**RE: PROPOSED WORK PLAN - POSSIBLE GROUNDWATER ISSUES  
DAVIS #1  
CASE NO. 3R0400**

**RE: Proposed Work Plan – Possible Groundwater Issues  
Davis #1**

# **BURLINGTON RESOURCES WORK PLAN PROPOSAL (7/25/05)**

## **Davis #1**

Attachments: Site Map

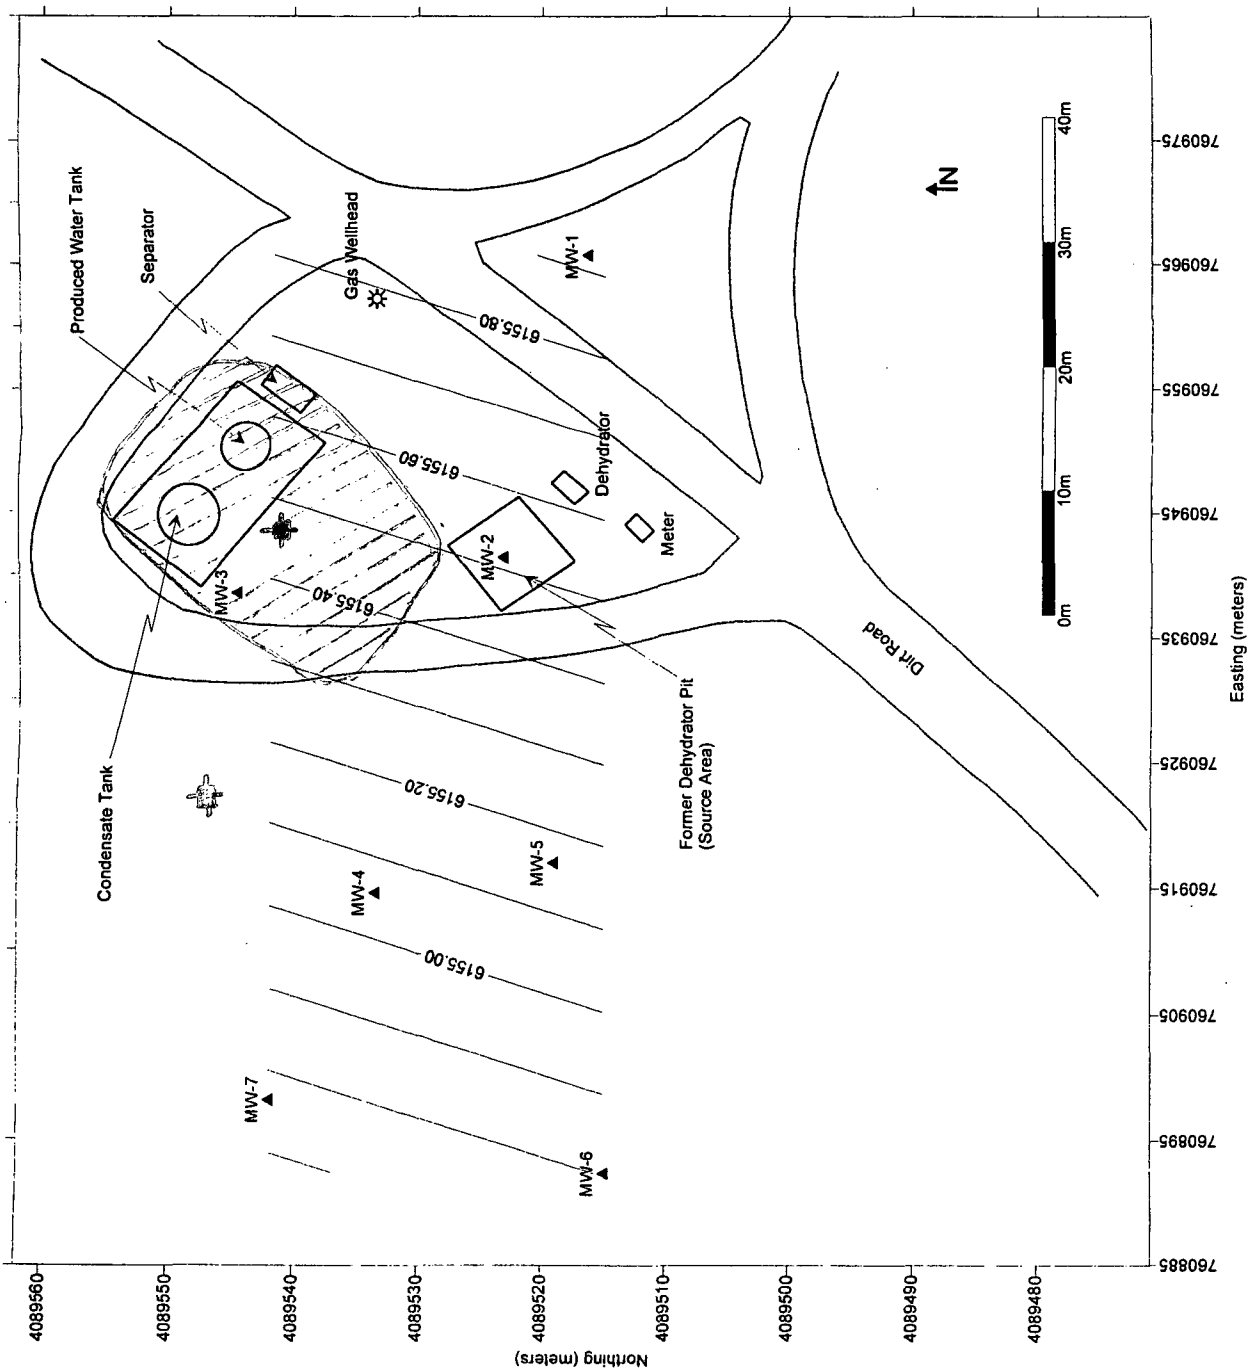
1. The initial source area monitoring well(s) will be sampled and analyzed for benzene, toluene, ethylbenzene, xylene (BTEX), total dissolved solids (TDS), major cations and anions and New Mexico Water Quality Control Commission (WQCC) metals.
2. BR will conduct all sampling and analysis activities using EPA approved methods and procedures including appropriate quality assurance/quality control (QA/QC).
3. All wastes generated will be disposed of at an OCD approved facility or in an OCD approved manner.
4. All documents submitted for approval will be submitted to the OCD Santa Fe Office with copies provided to the OCD Aztec Office.
